Giovanni Cirillo  
Managing Director, Planning Lab  
Level 24,  
Three International Towers,  
300 Barangaroo Avenue,  
Sydney NSW 2000  
p. 0447755799

**Submission in relation to Stage 1 development application no. SSD 16/7693 for a ballroom addition and comprehensive hotel upgrade for the InterContinental Hotel  
Property: 99-113 and 115-119 Macquarie Street, Sydney**

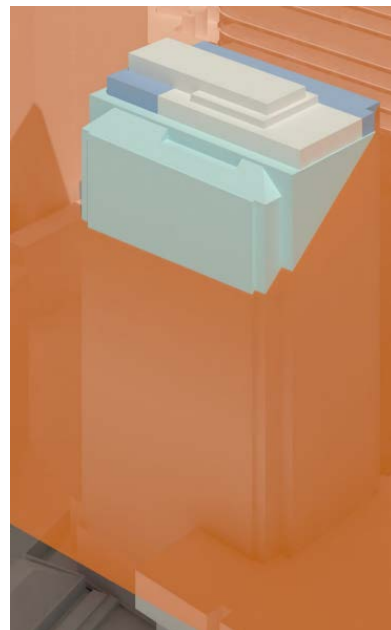
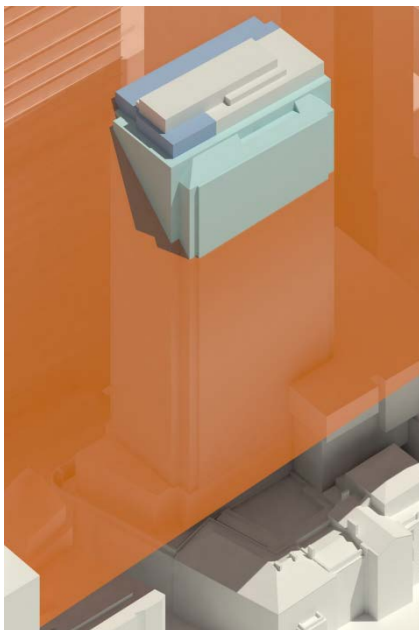
The Development does not comply with the 10m setback control in DCP 2012 along the Phillip Street elevation. In DCP 2012, setbacks above street wall height is to be 6m for east-west oriented streets, 8m for north-south oriented streets (such as Phillip Street) and a further 2m setback above Heritage Items (such as Transport House).

Instead, the ballroom and pool addition as proposed, extends entirely to the street frontage above Phillip Street (i.e. a nil setback). As with the Macquarie Street non-compliance, the SEARs specifically required the EIS to address the provisions of DCP 2012. In our view, the EIS has failed to provide adequate justification why a departure from these controls has been sought.

This clear disregard for the DCP 2012 is particularly severe, given that no attempt has been made to provide any setback whatsoever above Transport House. No attempt has been made to have any regard to the significance of the subject heritage item. In particular, the Heritage Submission concludes that:

*An integral aspect of the composition of the Phillip Street façade is that it emphatically expresses the top of the building to read as the skyline. The proposed addition flush with the face, and on top of the significant turret elements, would completely negate this important quality of the design (p. 7).*

## Sun Access Protection Map - Sheet SAP\_014

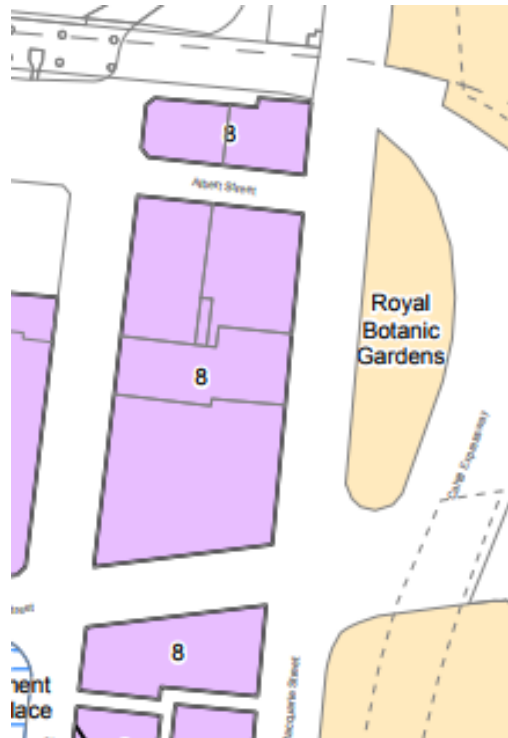
The Development does not comply with the sun access plane controls in clause 6.17 of LEP 2012, as shown in the extracts from Appendix 4E to the EIS. In addition, the Development is contrary to the objectives of clause 6.17 and clause 4.3 (height of buildings).

We consider that this provision is a prohibition rather than a development standard and as such, a consent authority is unable to grant consent if the development will result in any building on the land projecting higher than the sun access plane. Because the Development is SSD, the consent authority can grant consent where a partial prohibition arises. However, from a merits perspective, the applicant should provide strong and sufficient justification as to why a departure from the sun access plane controls should be accepted.

The EIS justifies this non-compliance by arguing that *“the changes to the roof club lounge on the rooftop does not result in increased overshadowing of the Royal Botanic Gardens”*. We consider this justification to be insufficient. Where the tower element of the Development already substantially breaches the LEP 2012 height control and towers above the Botanic Gardens sun access plane, the addition of further bulk and massing to the tower is unacceptable and contradicts the built form which the LEP 2012 attempts to achieve through the use of controls such as the sun access plane.

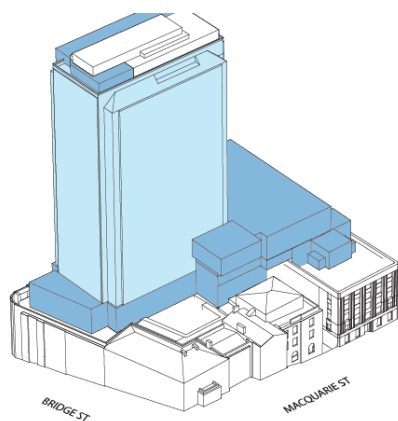
The photomontages misrepresent the design and do not match the architectural plans and axonometric diagrams lodged with the application. Specifically, the podium additions are not accurately shown above Transport House.

The photomontages misrepresent how any future building could be constructed and clearly do not accurately reflect with any reasonable competence, the necessary structural engineering required to support the proposed building. The building represented in the photomontages fundamentally cannot be built in this manner and to represent that it can, is both misleading and unacceptable.

As such, the photomontages are likely to confuse and potentially mislead the community as the photomontage may be relied upon by general members of the public more readily than architectural plans.
